NITRO 11 FEDERAL 2H

30-015-36100-00-S1

13. Describe Proposed or Completed Operation: Clearly state all pertinent details, including estimated starting date of any proposed work and approximate duration thereof. If the proposal is to deepen directionally or recomplete horizontally, give subsurface locations and measured and true vertical depths of all pertinent markers and zones. Attach the Bond under which the work will be performed or provide the Bond No. on file with BLM/BIA. Required subsequent reports must be filed within 30 days following completion of the involved operations. If the operation results in a multiple completion or recompletion in a new interval, a Form 3160-4 must be filed once testing has been completed. Final Abandonment Notices must be filed only after all requirements, including reclamation, have been completed and the operator has determined that the site is ready for final inspection.

Permanent Abandonment of Federal Wells
Conditions of Approval

Nitro 11 Federal 2H

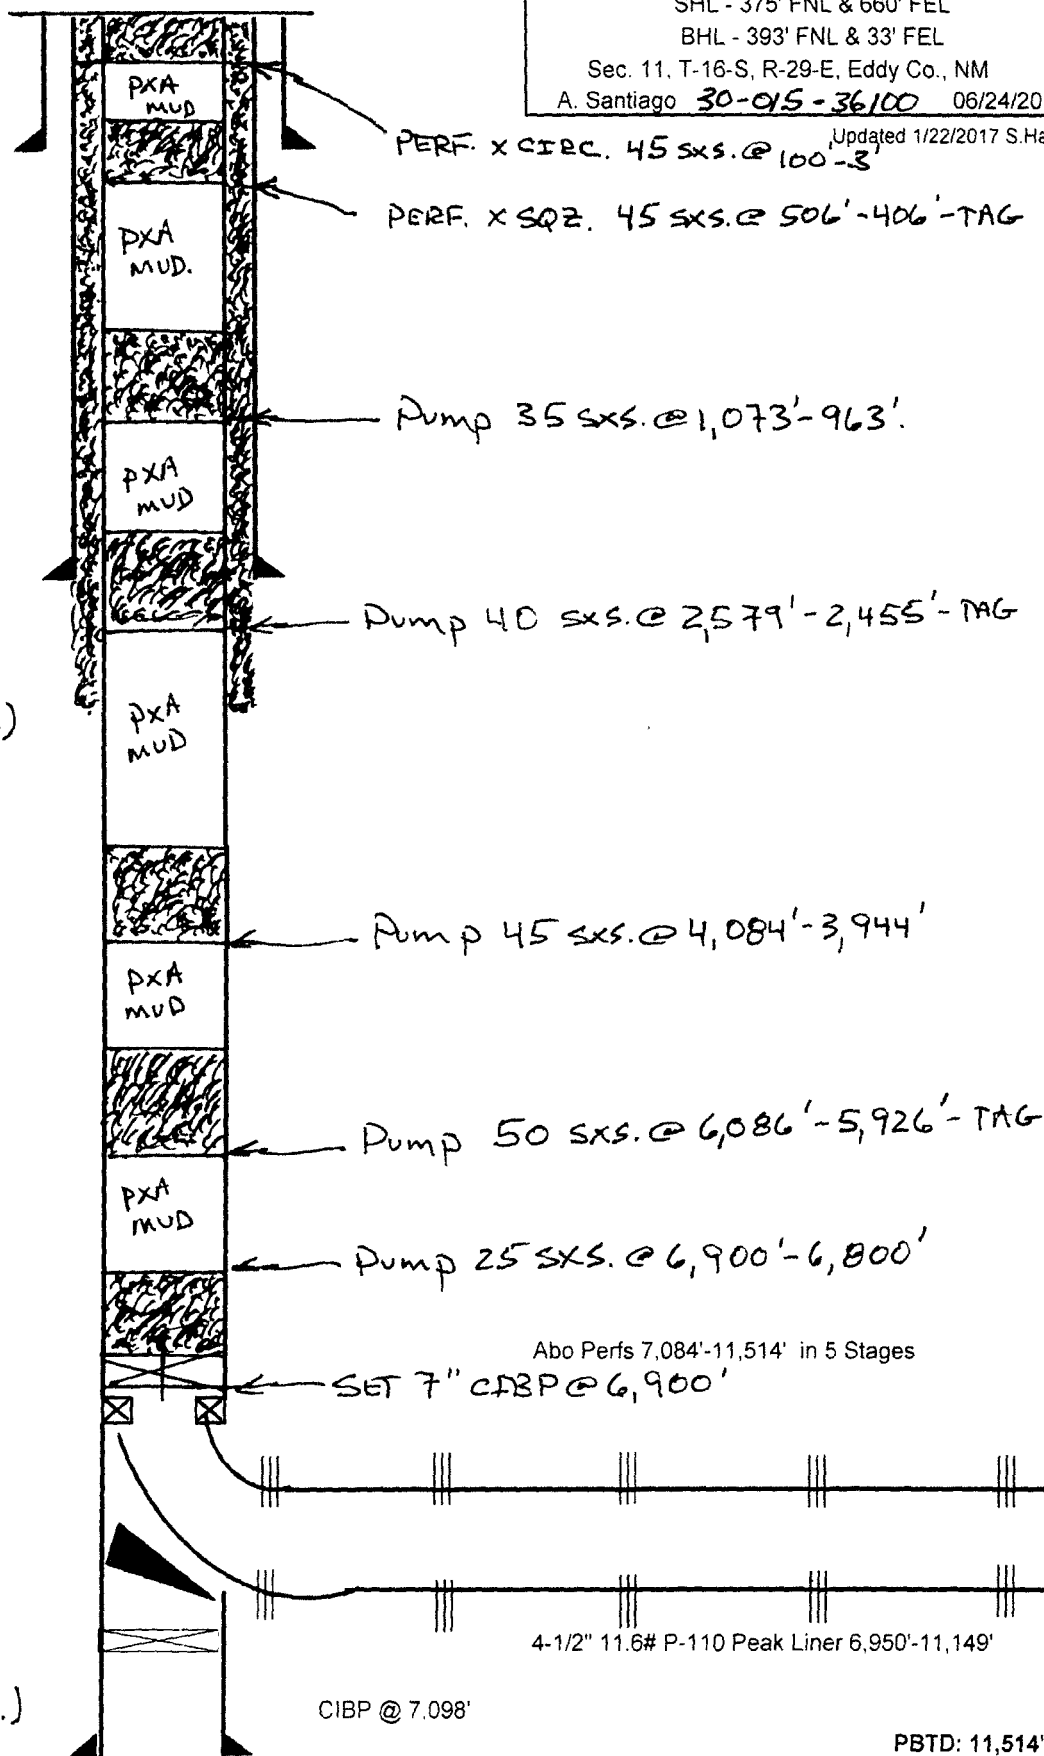
1) SET 7" CIBP @ 6,900'; PUMP 25 SXS.CMT. @ 6,900'-6,800'; CIRC. WELL W/ PXA MUD.

2) PUMP 50 SXS.CMT. @ 6,086'-5,926'(T/ABO); WOC X TAG CMT. PLUG.

3) PUMP 45 SXS.CMT. @ 4,084'-3,944'(T/GLOR.)

4) PUMP 40 SXS.CMT. @ 2,579'-2,455'(T/S.A., 9-5/8" CSG.SHOE); WOC X TAG CMT. PLUG

5) PUMP 35 SXS.CMT. @ 1,073'-963'(T/YATES).

6) PERF. X ATTEMPT TO SQZ. 45 SXS.CMT. @ 506'-406'(13'3/8" CSG.SHOE); WOC X TAG.

7) PERF. X CIRC. TO SURF., FILLING ALL ANNULI, 45 SXS.CMT. @ 100'-3'.

8) DIG OUT X CUT OFF WELLHEAD 3' B.G.L.; WELD ON STEEL PLATE TO CSGS. X INSTALL GROUND LEVEL DRY HOLE MARKER.

TOC @ ~~Unknown~~ 100' (CALC.)

TOC @ ~~Unknown~~ 100' (CALC.)
